MPC8260 PowerQUICC II™ Family Device Errata

This document describes all known silicon errata for the MPC8260 PowerQUICC II™ family of integrated communications processors. Refer to [Table 3](#) for a list of devices.

Figure 1. Transmit Timing for Cell-Level Handshake

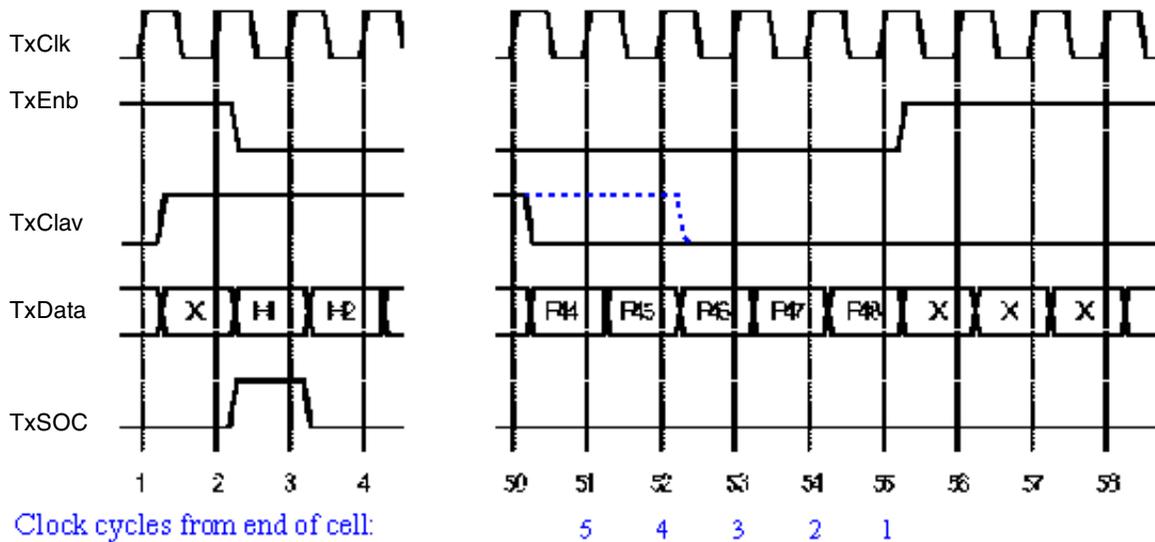
1. Master should not poll RxClav or pause cell transfer at 4 cycles before the end of cell transfer. Master should poll 2 cycles before the end of the current cell or later. This can be achieved by introducing a cell-to-cell polling (and transfer) delay, which is equal or larger then one cell transfer time. If this can be achieved, the impact on performance is minimal.
2. Configuring ATM only on FCC1 and setting FPSMR[TPRI] ensures highest priority to FCC1 Rx. In addition, for CPM utilization lower then 80% (as reported by the CPM performance tool based on UTOPIA maximal bus rate) the CPM performance is enough to guarantee that the RxFIFO does not fill up.

- Multi-PHY with single Clav polling—Master should ensure that the address corresponding to an MPC826xA slave is not placed on the address bus before 5 cycles before the end of a cell transfer to that slave.
